In the relocation and conversion of the Nine Mile Point Unit 2 current Technical Specifications (CTS) to the proposed Offsite Dose Calculation Manual (ODCM) used in support of the Improved Technical Specifications (ITS), certain wording preferences or conventions are adopted that do not result in technical changes (either actual or interpretational). Editorial changes, the elimination of redundant wording, reformatting and revised numbering are adopted to make the ODCM consistent with ITS.

Figure 4.1-1 (Page 1 of 1)
Site Area and Land Portion of Exclusion Area Boundaries

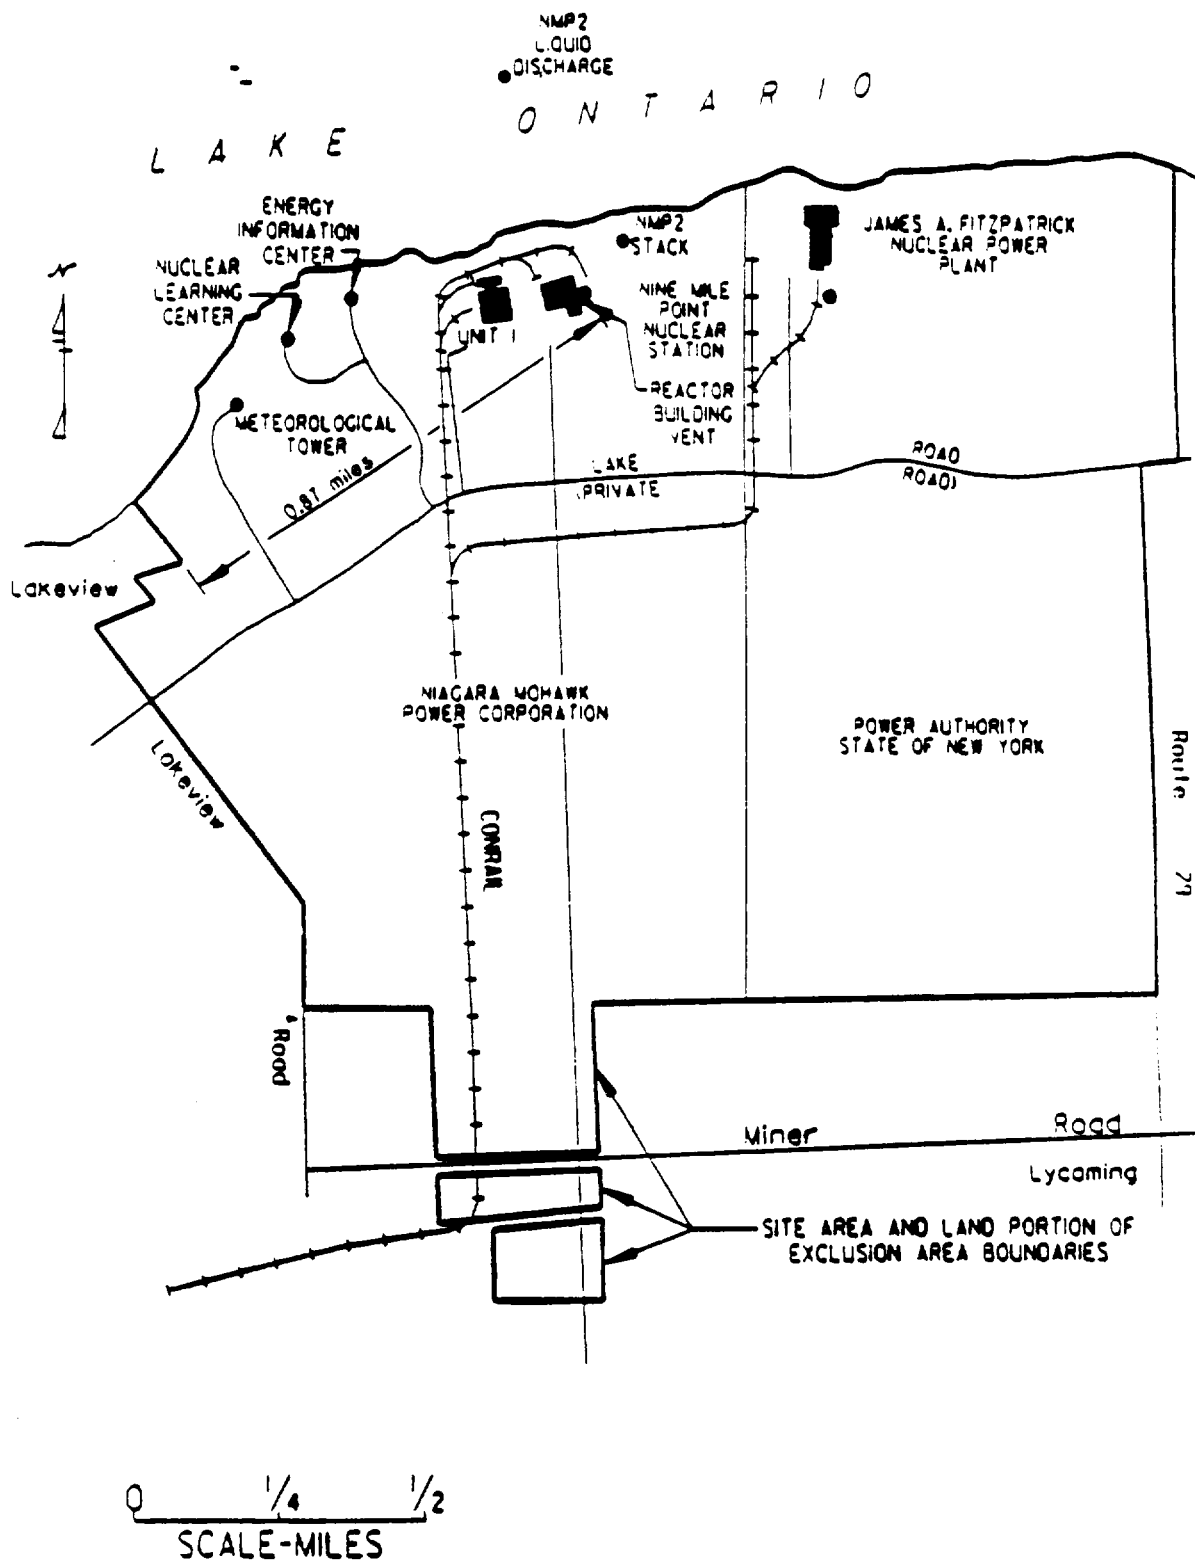
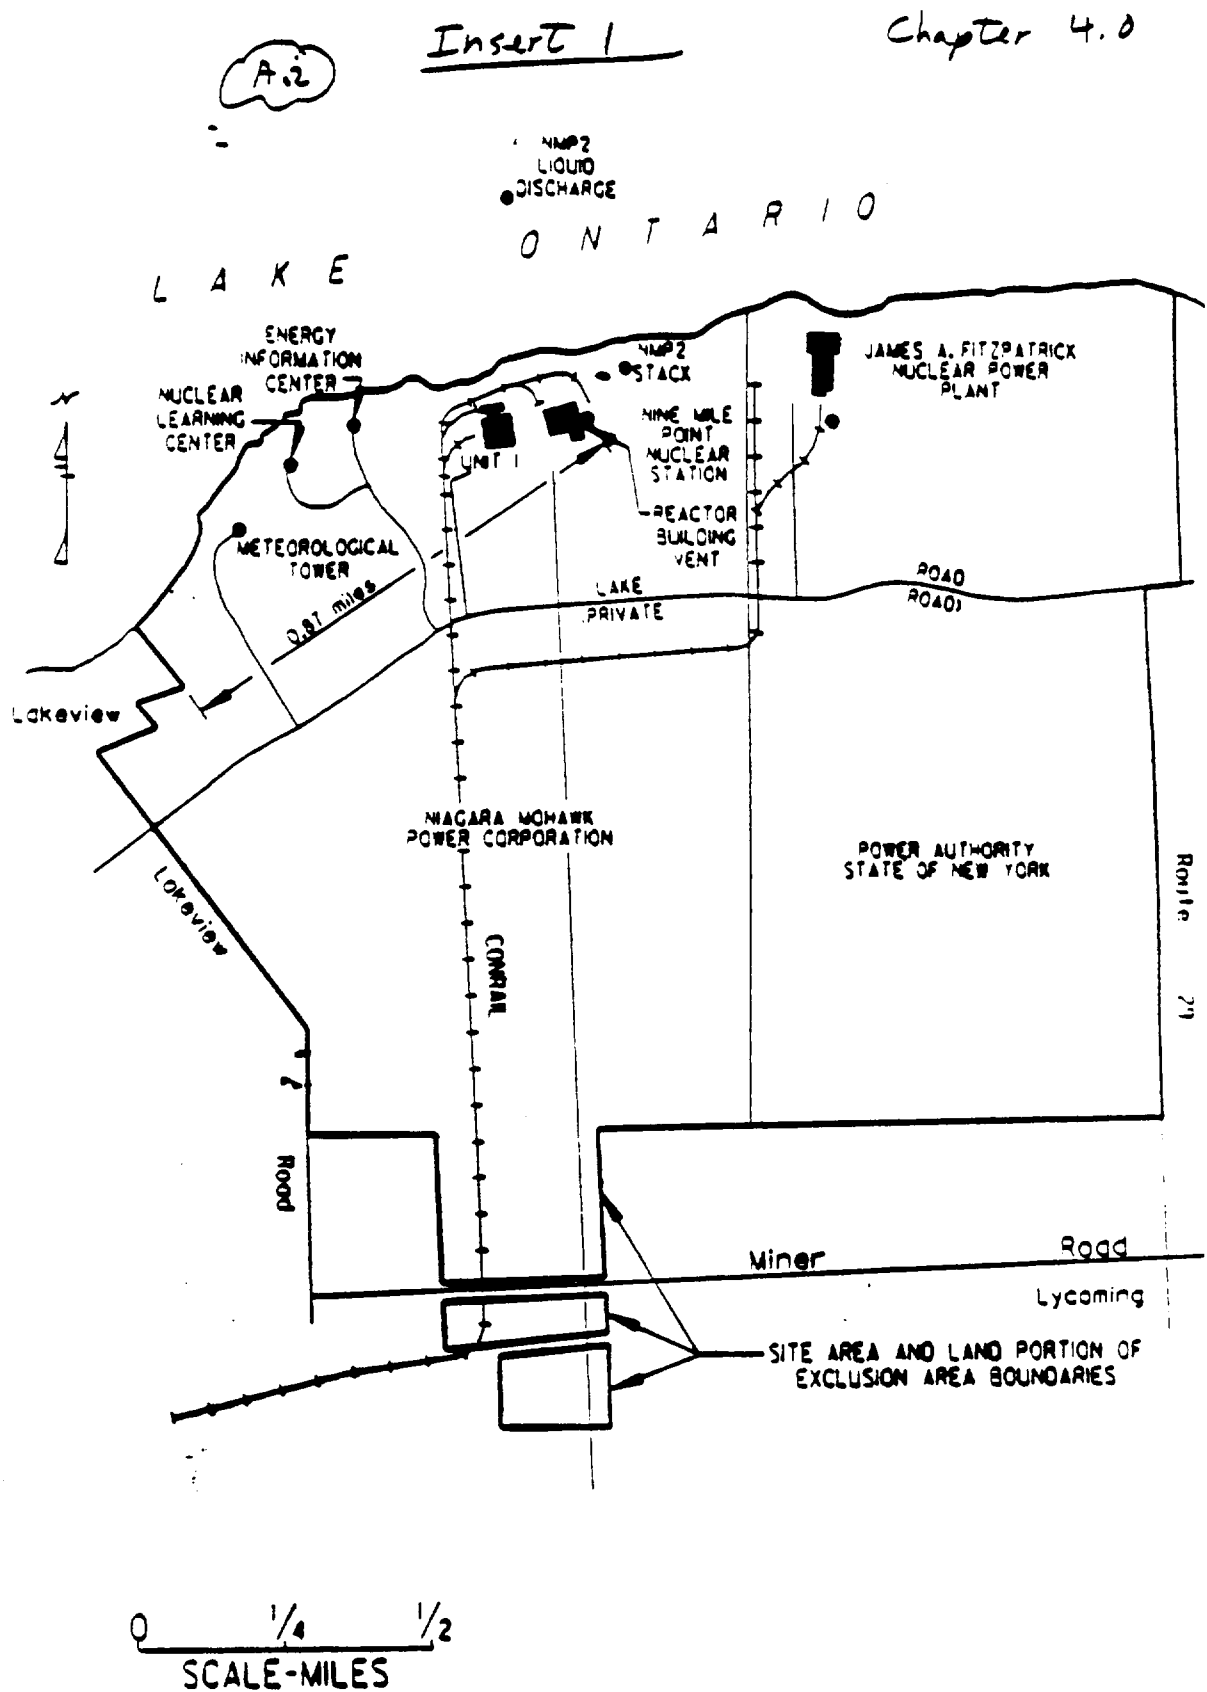
The site area boundary and the land portion of the exclusion area boundary are as shown in Figure 4.1-1. The lake portion of the exclusion area boundary is the area of Lake Ontario within a 2 mile radius of the Nine Mile Point Unit 2 reactor centerline.

The Nine Mile Point Nuclear Station and James A. FitzPatrick Nuclear Power Plant site, comprising approximately 1500 acres, is located on the shores of Lake Ontario, about 7 miles northeast of Oswego, New York. An exclusion distance of nearly 4000 feet is provided between the station and the nearest SITE BOUNDARY to the west, a mile to the boundary on the east, and a mile and a half to the southern SITE BOUNDARY.

In the specific case of the Design Features, the section has been deleted. The map has been relocated to D 1.0, Definitions, as Figure D 1.0-1.
